ADDENDUM TO REPORT FOR ITEM LPP05 DATED 1 JUNE 2021

SUBJECT: 15 WAIWERA STREET, LAVENDER BAY

APPLICATION NO. DA 20/21

AUTHOR: HUGH SHOULDICE, ASSESSMENT OFFICER

PHASE: DA REVISION: 1

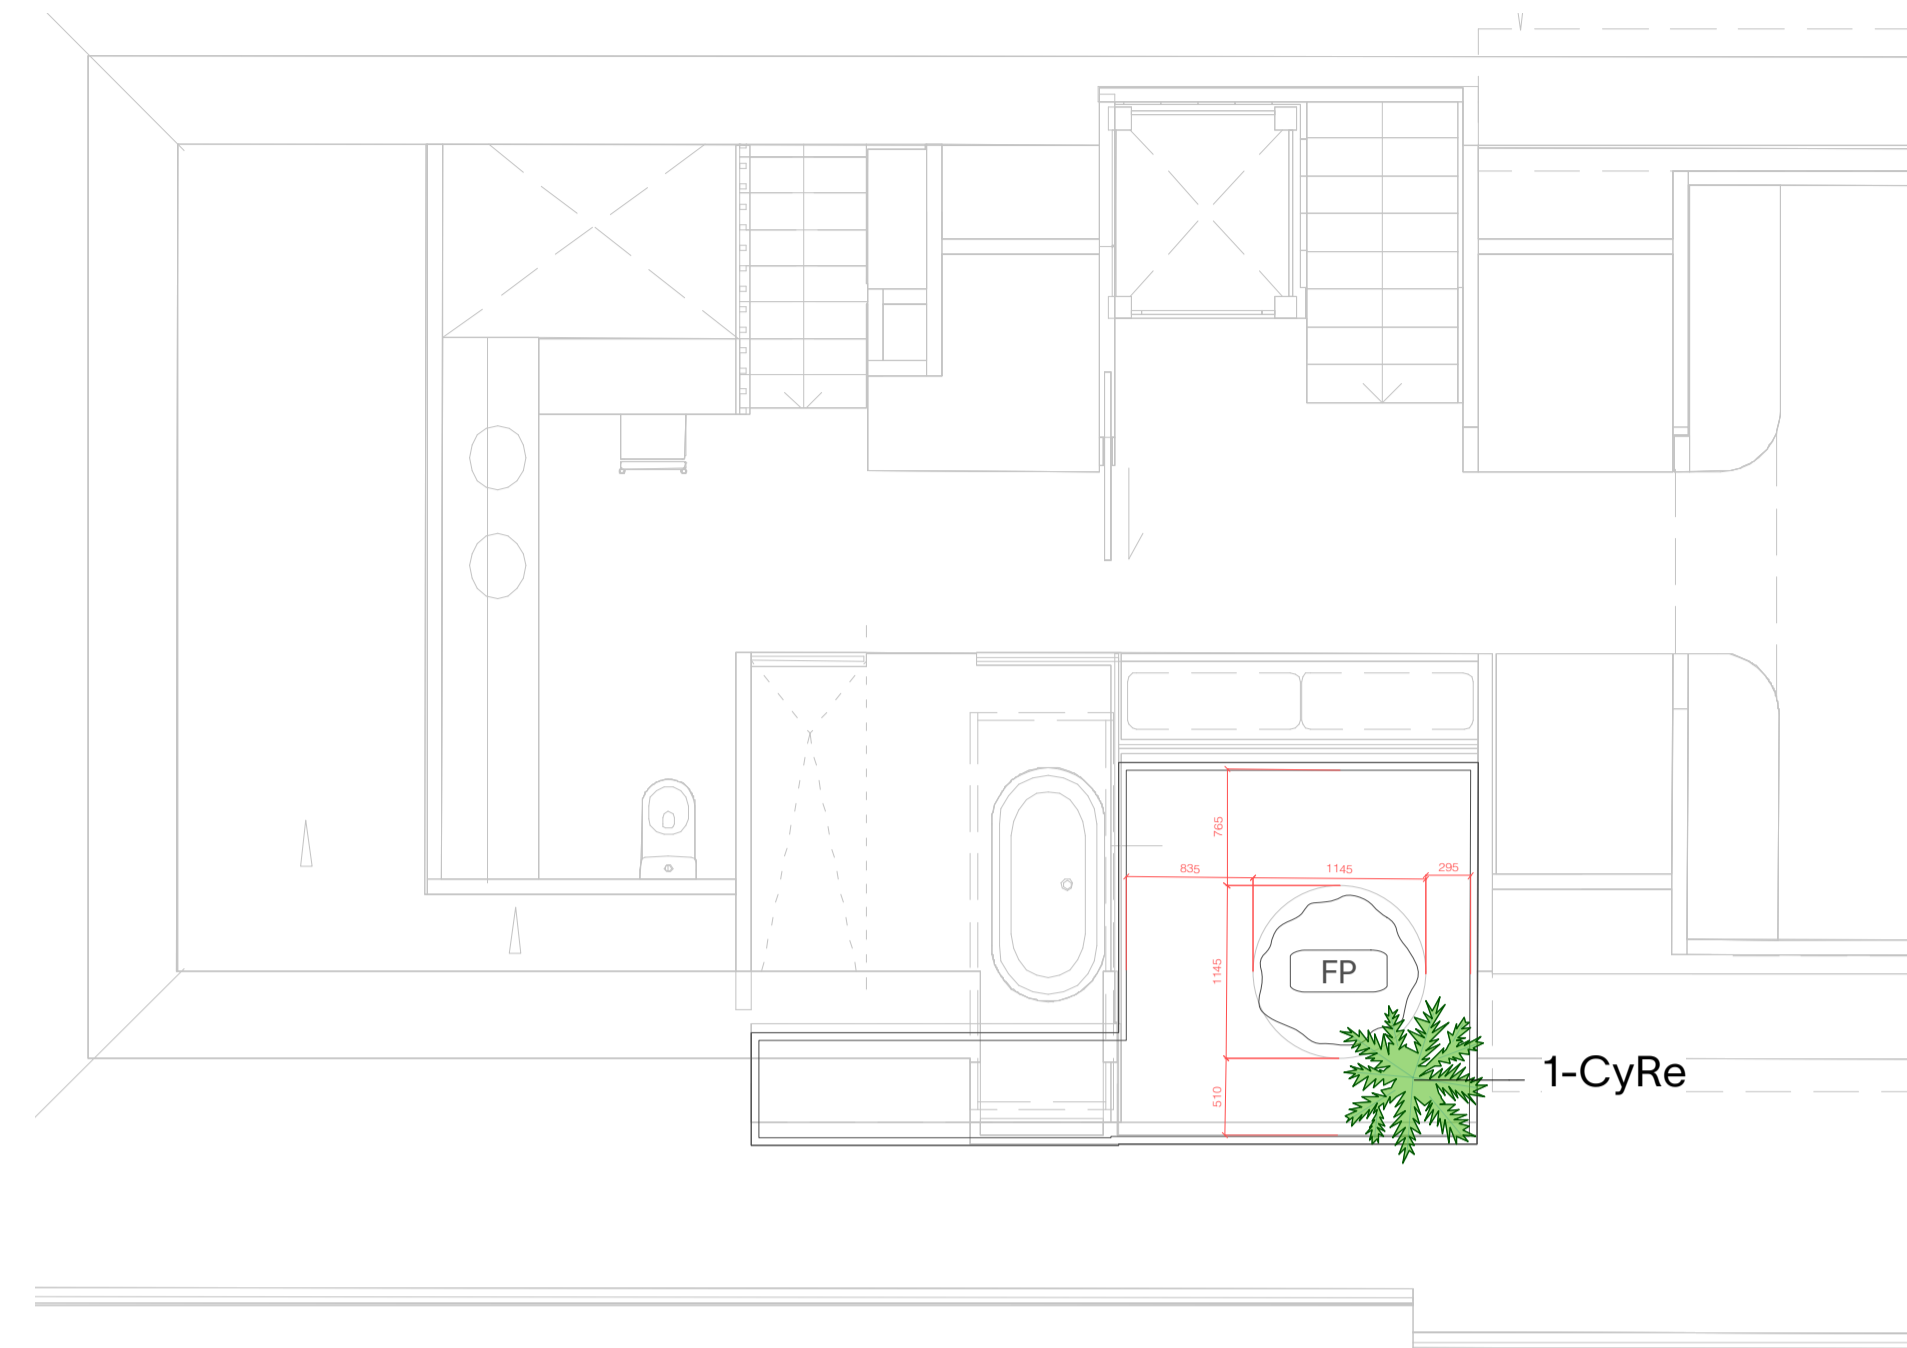
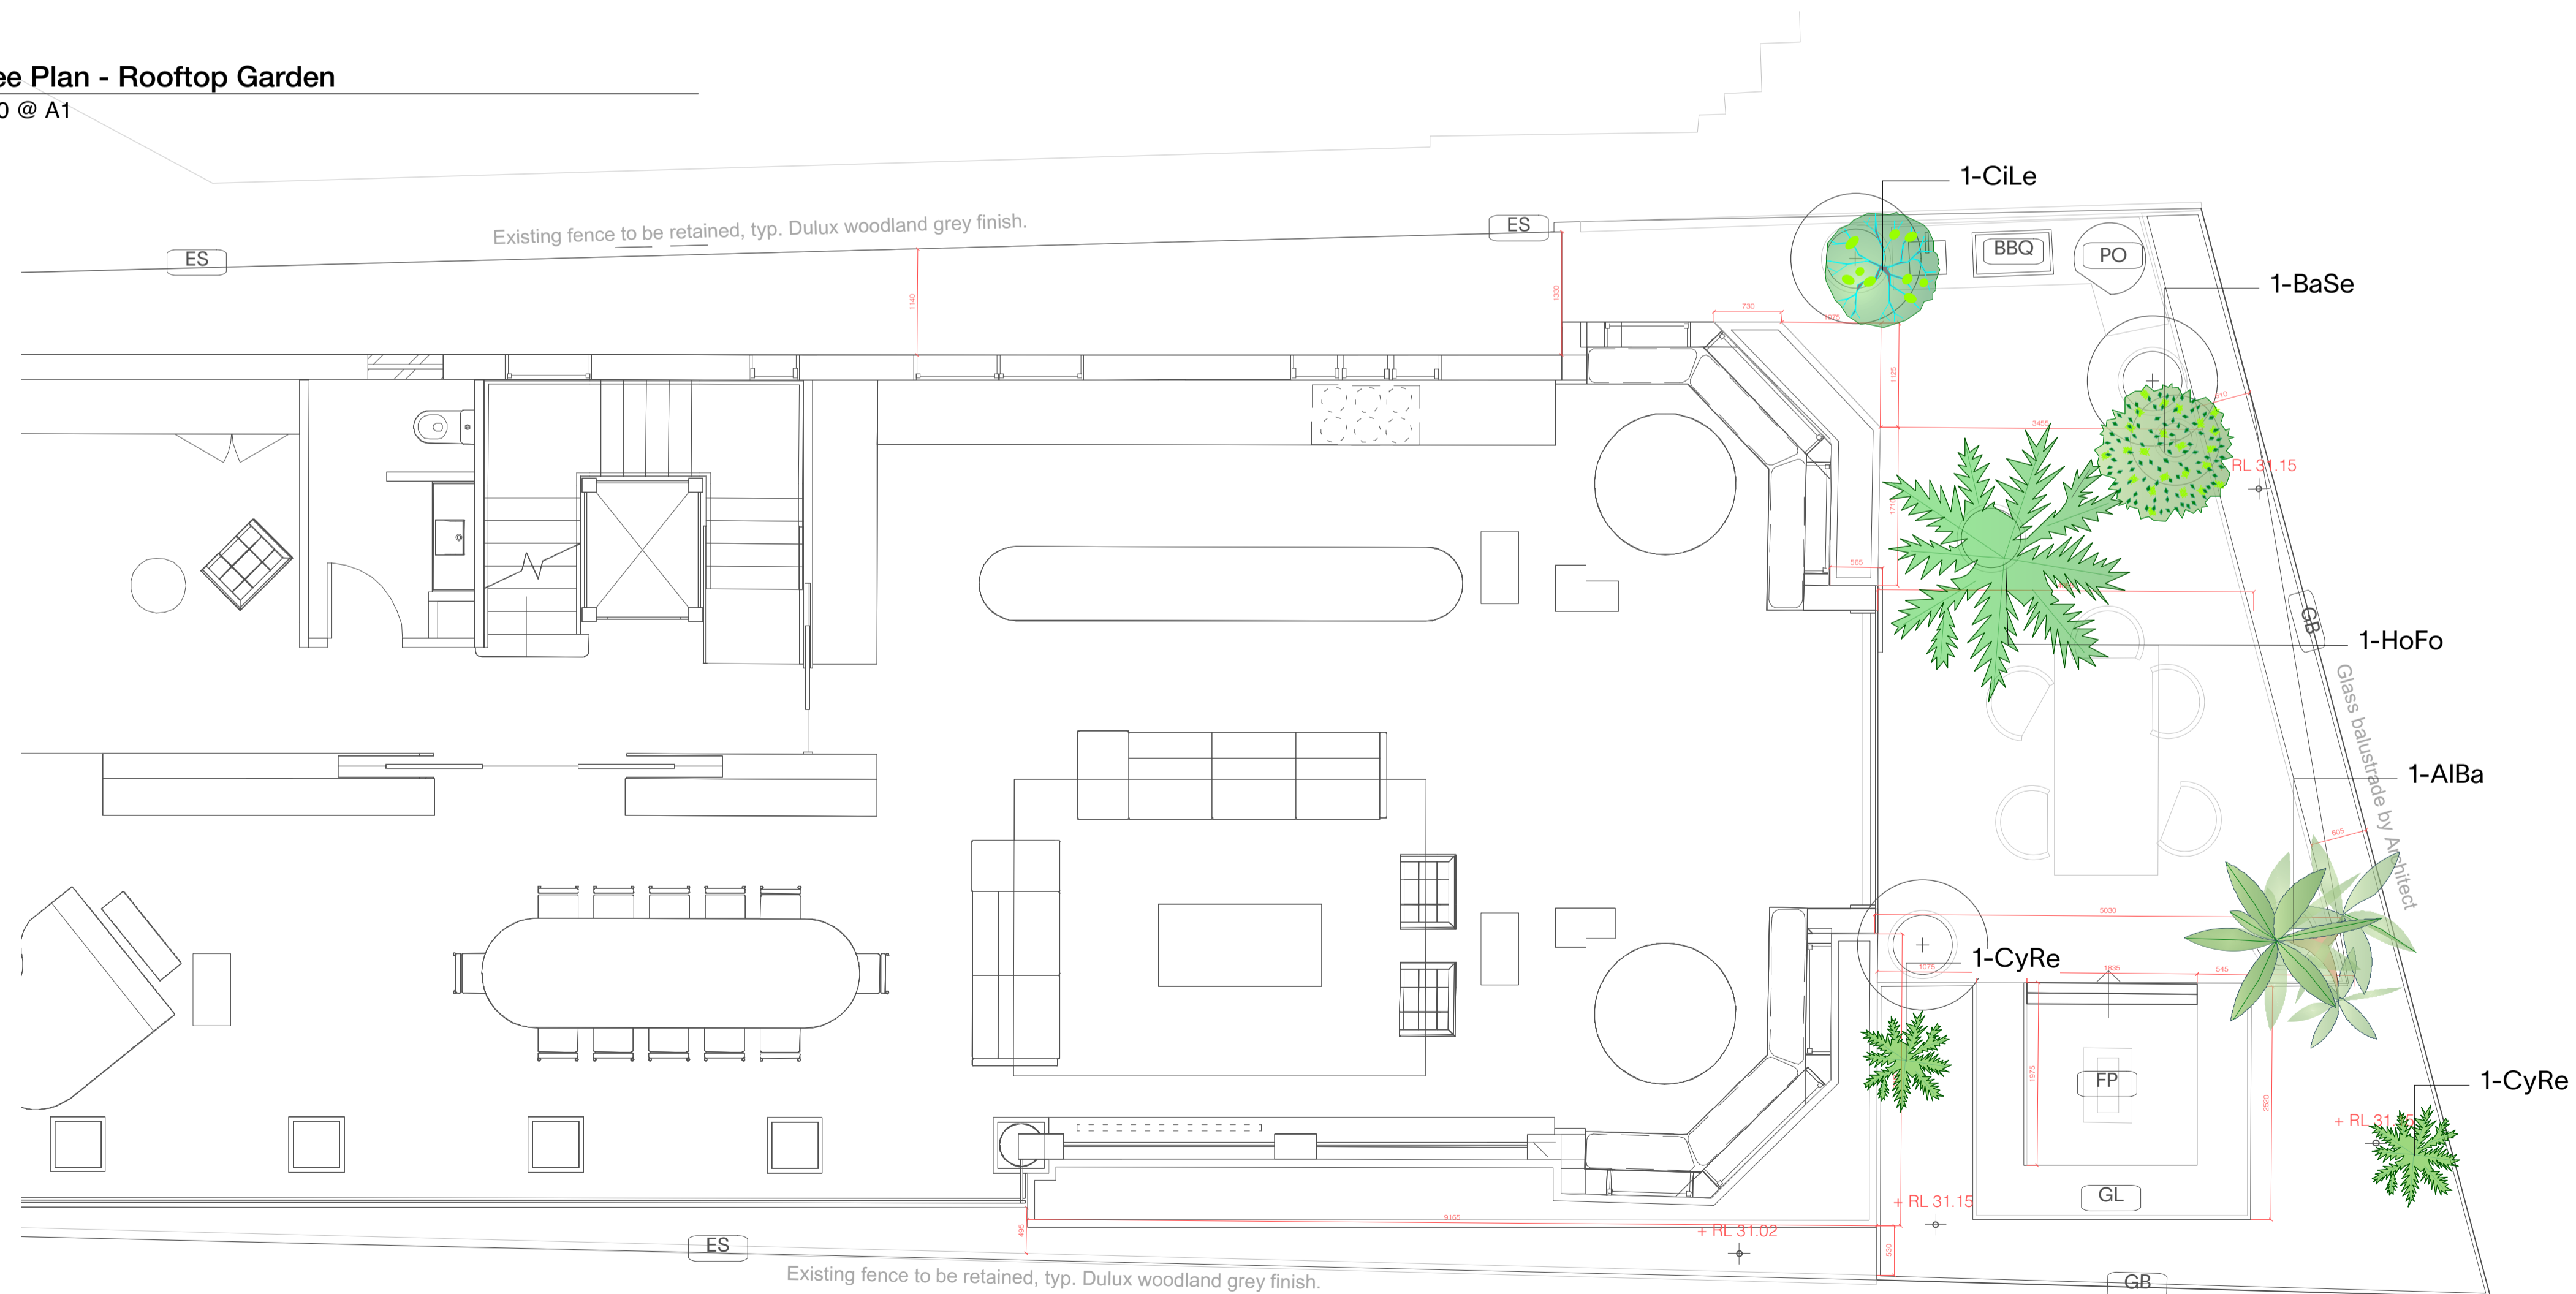
- *The Landscape Plan prepared by Philip Withers dated 18/11/20 is considered to be inaccurate –claiming that a total of 19 new trees are to be planted. The majority of these are claimed to be “trees”. However, they are considered to be small shrubs, palms, ferns or perennials, with only 2 actual canopy trees included in the claimed total of 19 trees (2 x Banksia serrata).*

- *An amended proposal ... that allows for the retention of T2 and T4, includes an amended arborist report with a detailed Tree Protection and Management Plan for same, and an amended Landscape Plan that accurately includes details of all plants is required. It should also ensure that plants chosen are characteristic of heritage plantings, and are not simply chosen due to their status as native plants (NSC while applauding the use of native plants, does not require their use per se, but prefers a planting palette in keeping with all site, locality, and heritage considerations).*

- The existing *Phoenix canariensis* (T4) is shown to be relocated within the subject site.
- A replacement mature *Magnolia grandiflora* (T2) is to be shown planted within the subject site.
- A tree planting schedule is to be provided on each sheet of the landscape plans.
- A heritage consultant with expertise in the landscaped design is to provide written certification that the revised design is consistent with the approved built form and heritage significance of the subject site.
